**SOIL, GEOLOGY AND GEOLOGIC HAZARD STUDY
SANCTUARY OF PEACE FILING NO. 1
15760 HIGHWAY 83 AND BENET LANE
EL PASO COUNTY, COLORADO**

PUDSP-19-002

February 11, 2019

**FLOODPLAIN MAP
SANCTUARY OF PEACE FILING NO. 1
BENET LAKE AND HIGHWAY 83
EL PASO COUNTY, CO.
FOR: MVE, INC.**

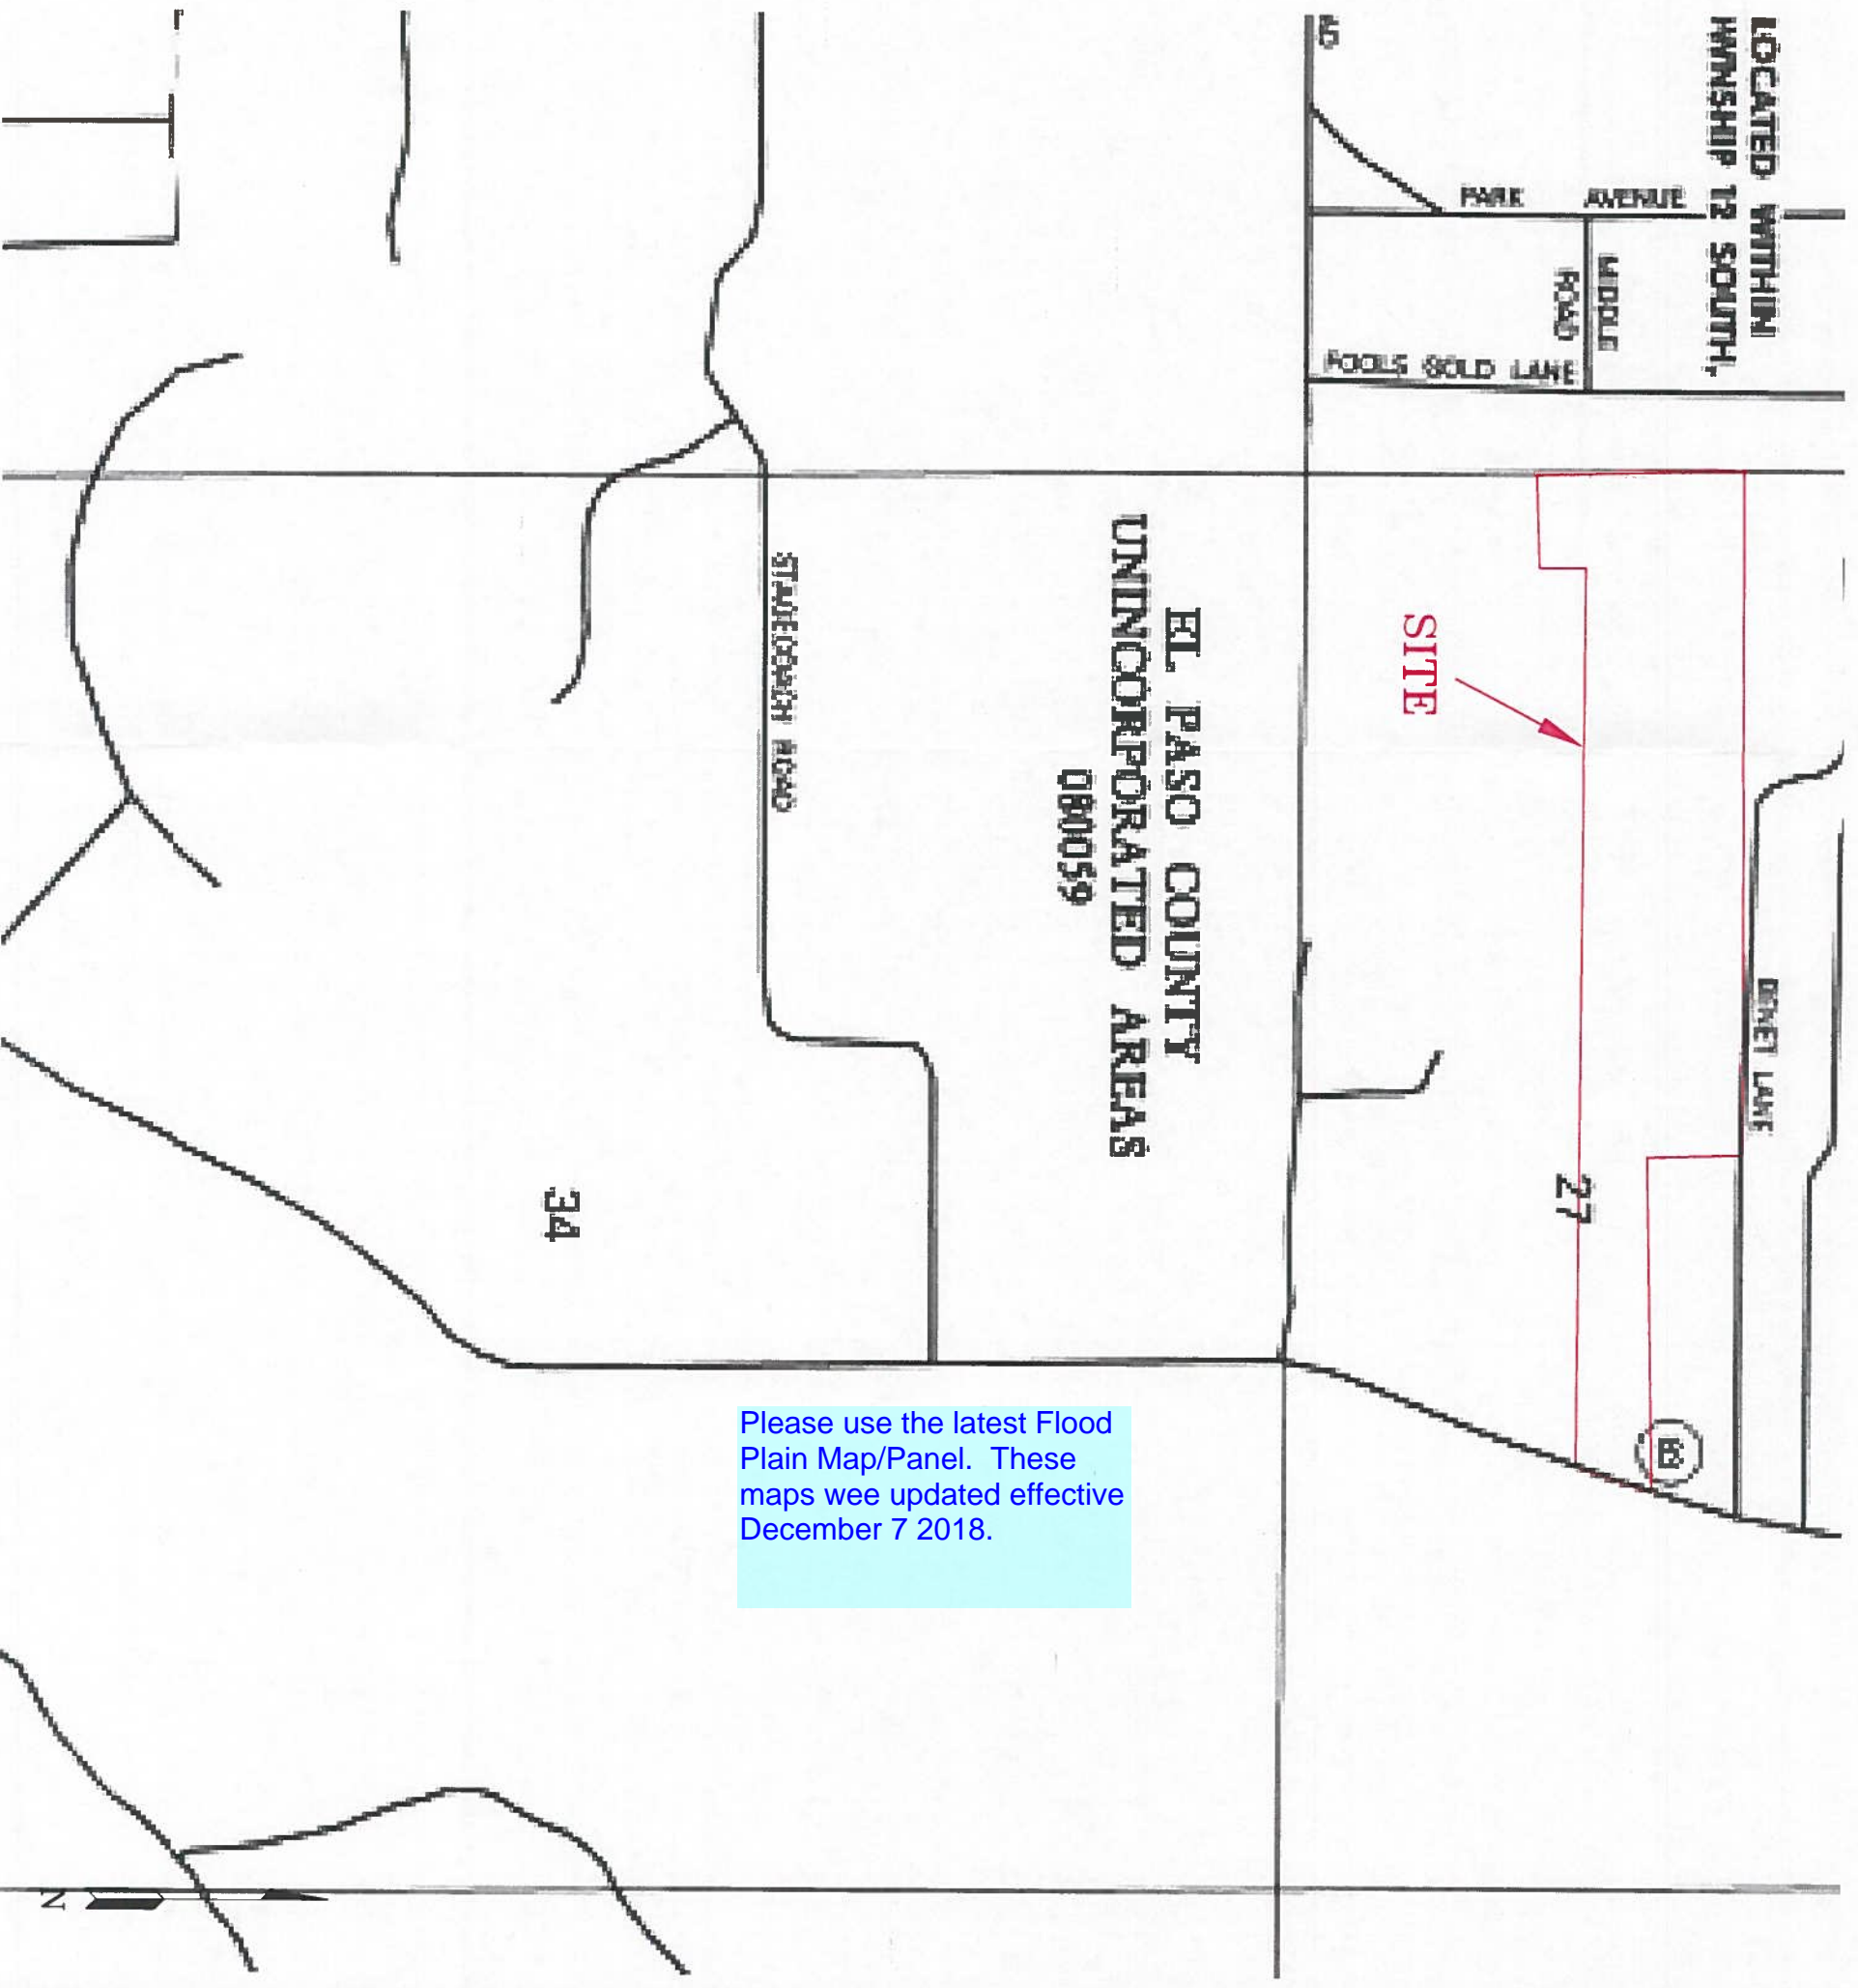
Please use the latest Flood Plain Map/Panel. These maps were updated effective December 7 2018.
